Re: Formal Case No. 1142, *In the Matter of the Merger of AltaGas, Ltd. and Washington Gas Holdings, Inc.*

**Comments by the Department of Energy and Environment
on behalf of the District of Columbia Government
Concerning AltaGas Ltd.’s Climate Business Plan**

Figure 1. Corrected calculations of 2050 fossil and lower-carbon gas sales.

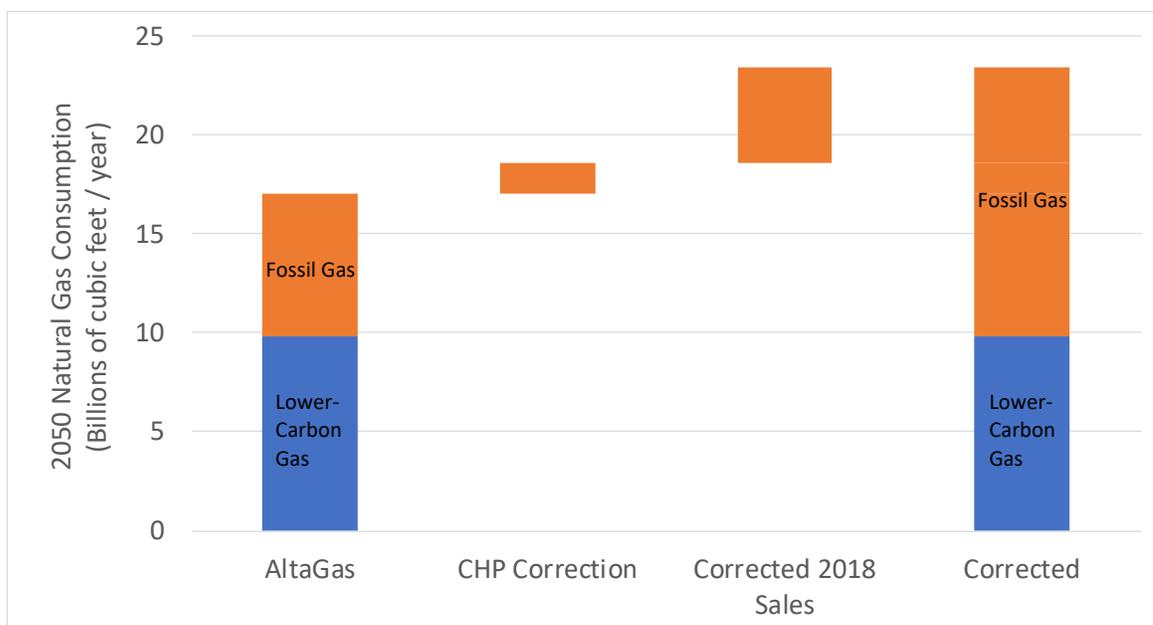
The CBP lays out a path to acquire 9.8 BCF of low-carbon gas (renewable natural gas, hydrogen, and power-to-gas). As shown in Figure 1, with total consumption of 18.58 BCF, the

actual fossil fuel consumption would be 8.78 BCF, or 47 percent of sales. After further adjusting sales projections up to account for the actual 2018 sales, the fossil fuel fraction would be at least 57 percent, and 2050’s fossil gas consumption would be more than 40 percent of 2018’s level. Retaining more than 40 percent of today’s fossil gas consumption in 2050 is not consistent with the goal of carbon neutrality and the Sustainable Plan DC 2.0.

Figure 2. Comparison of different data sources for District of Columbia Gas consumption (The outlier starting point for AltaGas’s CBP analysis is highlighted in red.)

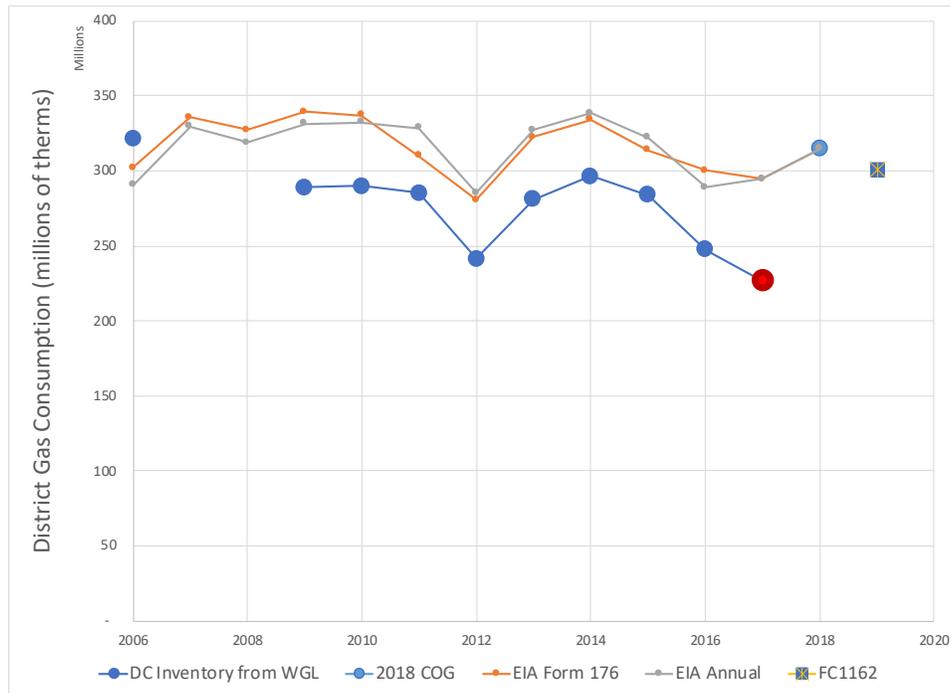
Given the multiple confirmations of higher sales in 2018 and 2019, it is unreasonable to begin the CBP analysis at a sales (and therefore emissions) level almost 20 percent below the actual baseline emissions. Further, it is unreasonable to assume that the reduction represents a permanent reduction. Figure 2 shows the time series of the different data sources we have compared. It appears that WGL has provided inaccurate data to the MWCOG, which has been used as input data for the DC GHG Inventory.

The CBP’s discussion of emission reductions between 2006 and 2017 rests on a flawed foundation, and this flaw taints the CBP’s analysis of subsequent emission reductions. If AltaGas had taken Clean Energy DC as the starting point for its future business plan development, and built a future vision without fossil fuel use, its analysis would not have been subject to this error before it even began.

Figure 3. ICF Figure 53—lifecycle GHG emission factor ranges for RNG feedstocks, South Atlantic Region

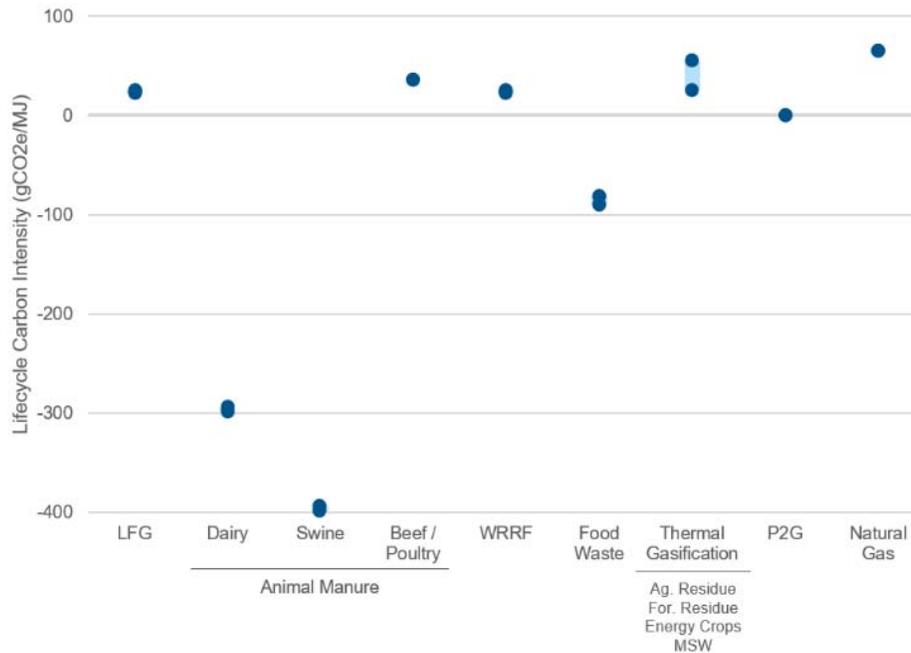
Specifically, Biogas Study Figure 53, reproduced below, credits RNG from swine manure with an emissions factor of approximately -400 gCO₂e/MJ and from dairy manure of

By choosing a baseline that presumes no mitigation of methane through 2050, ICF makes a highly questionable assumption that the default for dairy and swine farms will be for unmitigated methane emissions from anaerobic lagoons to continue through 2050. Additionally, this baseline ignores additional concerns, such as: (1) leaks caused while transporting the RNG between the farm and the gas transmission system; (2) the fact that more methane gets produced in digesters or lagoons than would be produced in other manure management strategies, such as spreading it on fields.⁴⁷

A more reasonable assumption, given the market and policy trends toward a carbon-constrained world for the next few decades, is that unconstrained methane emissions will become the exception, not the rule. This would change the baseline on RNG emissions, making it more

Figure 4. ICF Figure 14—incremental cost of RNG for WGL’s portfolio

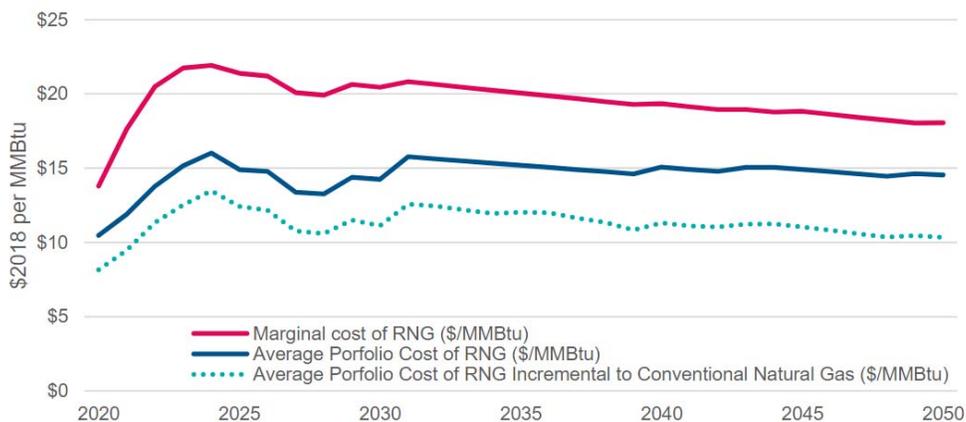
In a functioning and competitive market, the price of a commodity is set by the marginal supplier. If an RNG market were to develop as AltaGas claims it will, the same economic principles would also hold true. This means that the low-cost suppliers of RNG would not be selling their gas at their cost (as assumed by the CBP). They would sell their product at the price set by the higher-cost marginal supplies. ICF shows the difference between the average portfolio cost of RNG and the marginal cost of RNG in its Technical Study Report. ICF Technical Study Report Figure 14 shows that the marginal cost is roughly 30 percent higher than the average cost.⁵⁴

While ICF presents a price range for each RNG feedstock, it is unclear how these are used to produce total cost estimates. Since suppliers will price their RNG closer to the marginal cost shown in the ICF's Figure 14 than the average portfolio cost that CBP assumes, AltaGas should recognize that RNG will cost more than the CBP assumes and adjust its scenarios accordingly. Based on ICF's Figure 14, it appears that price at the marginal cost would roughly double the incremental cost of RNG supply, adding about one billion dollars to the cost of the preferred case.

Figure 5. ICF Figure 54—change in PJM total production cost by case from 2020–2050

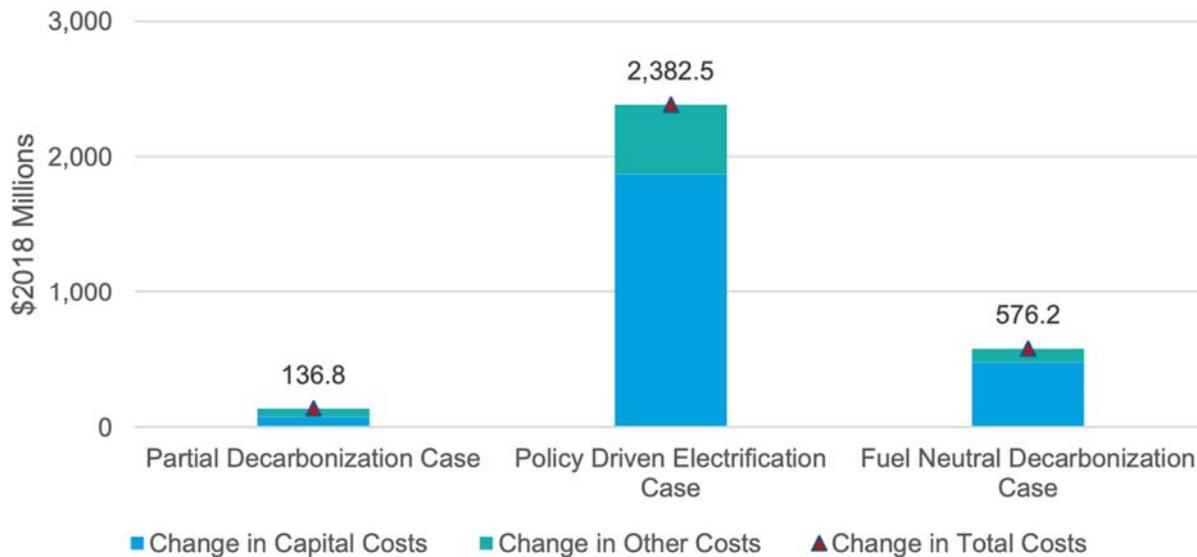
Together, ICF Tables 15 and 9, and ICF Figure 54 show the basis for AltaGas and ICF’s claim that the Electrification case is about \$2.7 billion dollars more expensive than the Fuel Neutral case. However, the analysis is flawed and its conclusion cannot be supported for the following reasons:

ICF presents three substantial costs resulting from increased electric consumption: (1) \$6.2 billion for “incremental electricity purchases” (ICF Table 15); (2) \$2.4 billion for “PJM total production cost” (ICF Figure 54); and (3) \$2.8 billion for transmission and distribution (ICF Table 9).

In response to a question from the District, AltaGas stated that the \$6.2 billion “incremental electricity purchases” figure is based on residential and commercial electric rates and is intended to reflect the “impact of changes in ... electricity consumption to the cost of energy purchases for customers.” Retail rates include both the cost of energy supply and the cost of infrastructure. However, the second and third of ICF’s assumed costs are exactly these two costs: the increased costs of electric supply in the wholesale market, and increased costs for electric infrastructure.

Figure 6. AltaGas unrecovered cost of utility services in the Fuel Neutral and Electrification cases

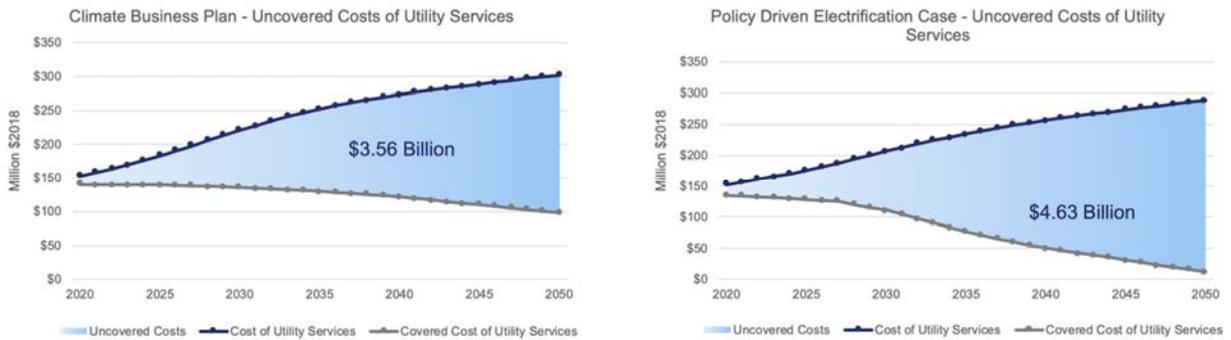
According to this figure, AltaGas projects that inflation-adjusted gas delivery rates would need to triple by 2050 in the Fuel Neutral Case in order to recover the full cost of service—and that even without the reduction in sales resulting from the CBP, delivery rates would need to double. Presumably these costs are what AltaGas believes are necessary to maintain its gas

In addition, according to this figure, and as discussed earlier, AltaGas is apparently assuming that Washington Gas will maintain a complete gas system capable of serving every customer until 2050 even if the District opts to electrify all buildings and transportation. In making this assumption, AltaGas deliberately creates an avoidable enormous stranded asset problem. This analysis illustrates the conflict between PROJECTpipes and the District's climate policy.
